8.2 Functional Block Diagram

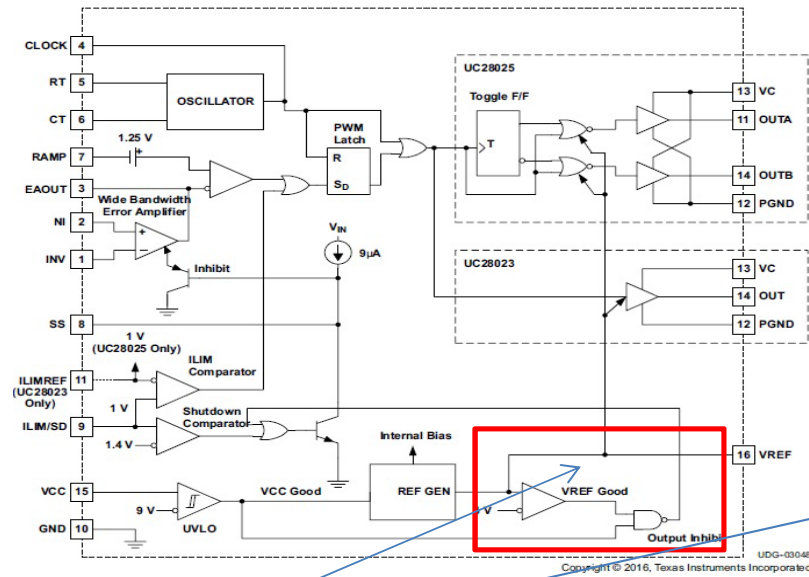
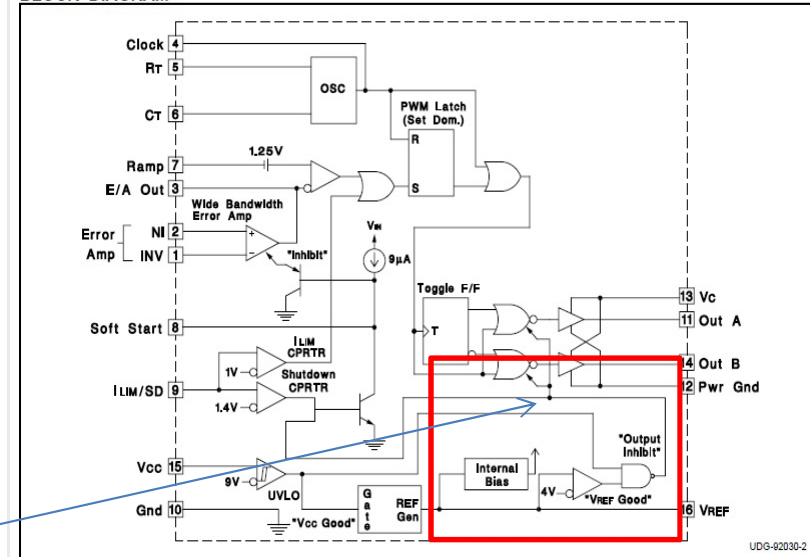
- 6 See the block diagram.
 There is a difference in the red frame.
 For what reason did you change this?
